# UNITED STATES PATENT AND TRADEMARK OFFICE

APPLICATION NO.	FILING DATE	FIRST NAMED INVENTOR	ATTORNEY DOCKET NO.	CONFIRMATION NO.
10/587,469	03/26/2007	Rodney James Dry	T2211-11786US01	5189
181 7590 12/03/2009 MILES & STOCKBRIDGE PC 1751 PINNACLE DRIVE SUITE 500 MCLEAN, VA 22102-3833				
EXAMINER				
MC GUTHRY BANKS, TIMA MICHELE				
ART UNIT		PAPER NUMBER		
1793				
NOTIFICATION DATE		DELIVERY MODE		
12/03/2009		ELECTRONIC

### Office Action Summary

## **DETAILED ACTION**

**Fig.1**

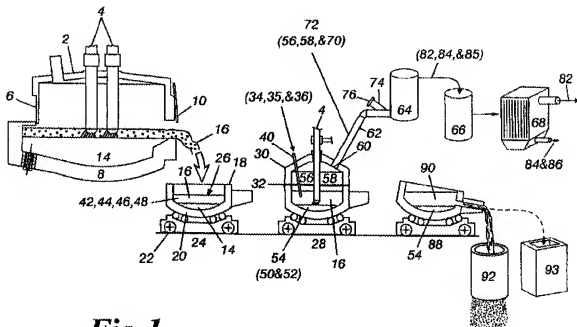
Vallomy teaches a method for recovering metal values from liquid slag from a steelmaking furnace as shown below in Fig. 1:

Steelmaking slag 16 from the EAF 6 is added to molten metal 14 in vessel 18. The molten metal contains iron (column 2, line 63). SiO<sub>2</sub> is introduced into the molten slag (line 42). Carbon, baghouse dust and inert gas are inserted in the vessel via a lance (column 5, lines 42-44). Metallic oxides are reduced (column 5, line 30). Regarding the limitation that the slag forming agent directly as opposed to pre-treating, it would have been obvious to one of ordinary skill in the art at the time the invention was made that the heated SiO<sub>2</sub> added to the vessel reads on the claimed invention, since applicant does not claim what the pre-treating steps entail. However,

Vallomy does not teach injecting with sufficient momentum to penetrate the molten bath as in Claim 1.
